Reference: Hanford Waste Vitrification Plant
DOE Contract DE-AC06-86RL10838
Fluor Contract 8457

NUMBER	REV	DATE	TITLE
DCN - #0067	1	3/24/94	DCN TITLE: **ROUTE 4S INTERSECTION FOR TOB PARKING LOT** "RELEASED FOR CONSTRUCTION"

DESIGN CHANGE NOTICE

DCN – 0067	REV 1	PAGE 1 OF 14
DCN TITLE: ROUTE 4S INTERSECTION FOR TOB PARKING LOT		DATE INITIATED: 2/9/94
		PACKAGE NO.: CWBS A130

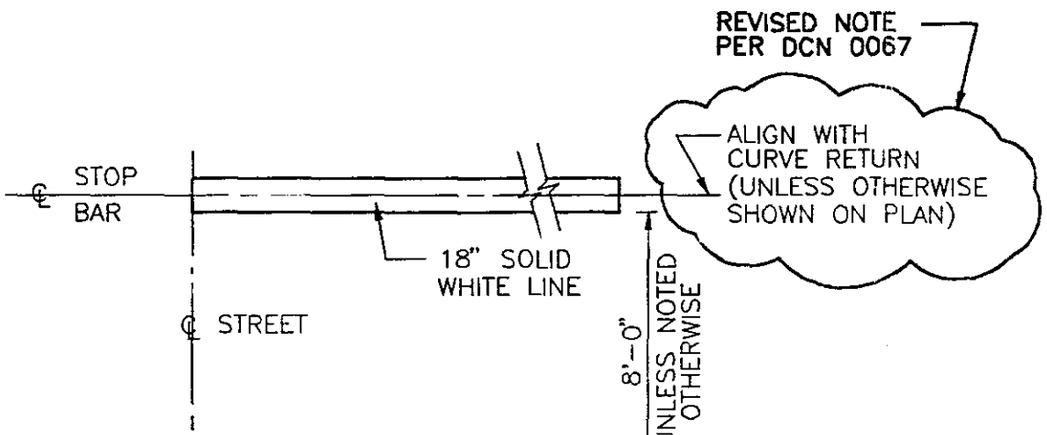
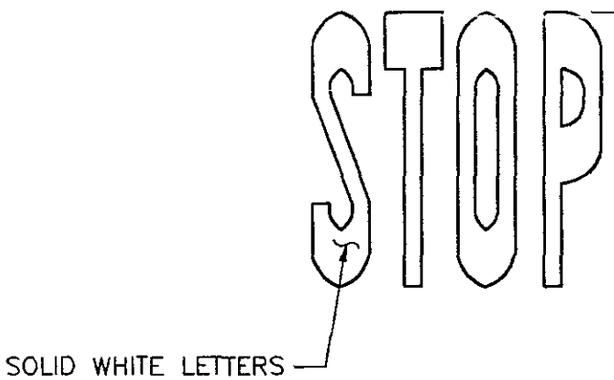
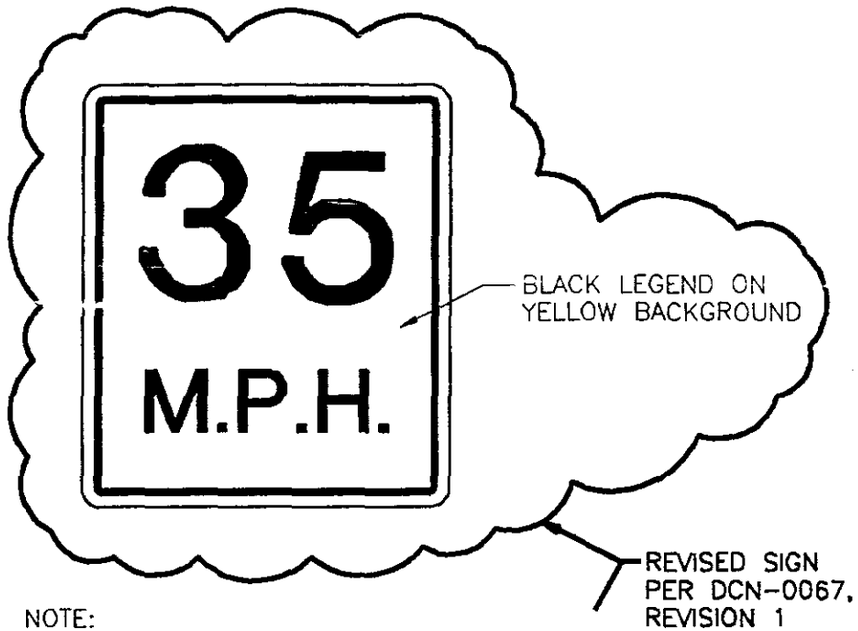
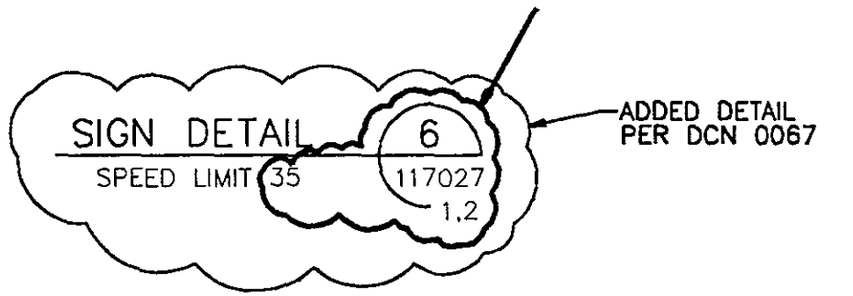
REVISION 1: REPLACE ROUTE 4S 35 MPH MANDATORY SPEED LIMIT SIGNAGE WITH 35 MPH WARNING SIGNS AND ADD "T" INTERSECTION AND "THRU TRAFFIC MERGE LEFT" SIGNS.

DOCUMENT NUMBER	SHT/ PAGE	REV NO	DOCUMENT NAME	INCLD Y/N	DESCRIPTION OF CHANGE
H-2-117027	2	(NEW SHT)	CIVIL, HIGHWAY TURNOUT SITE PREPARATION DETAIL	Y	(CONTINUED FROM PAGE 2) REV 1: REVISED SECTION CALLOUT (DCN PAGE 10). REVISED SECTION CALLOUT (DCN PAGE 11).
H-2-117028	1	1	CIVIL, SITE PREPARATION STRIPING AND SIGNAGE DETAILS	Y	ADDED SIGNAGE DETAILS REV 1: DCN-0067 PAGE 12, REVISED SIGN DETAIL 13 PAGE 13, REVISED SIGN DETAIL 6 PAGE 14, REVISED SIGN DETAIL 14

SIGN DETAIL 14
117027
2

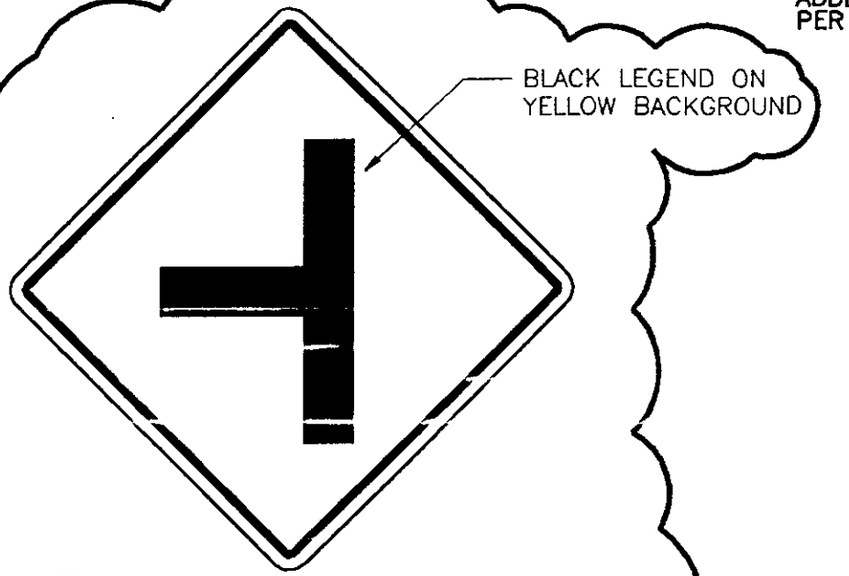
ADDED DETAIL
PER DCN 0067

REVISED DETAIL NO. 14
PER DCN-0067, REVISION 1
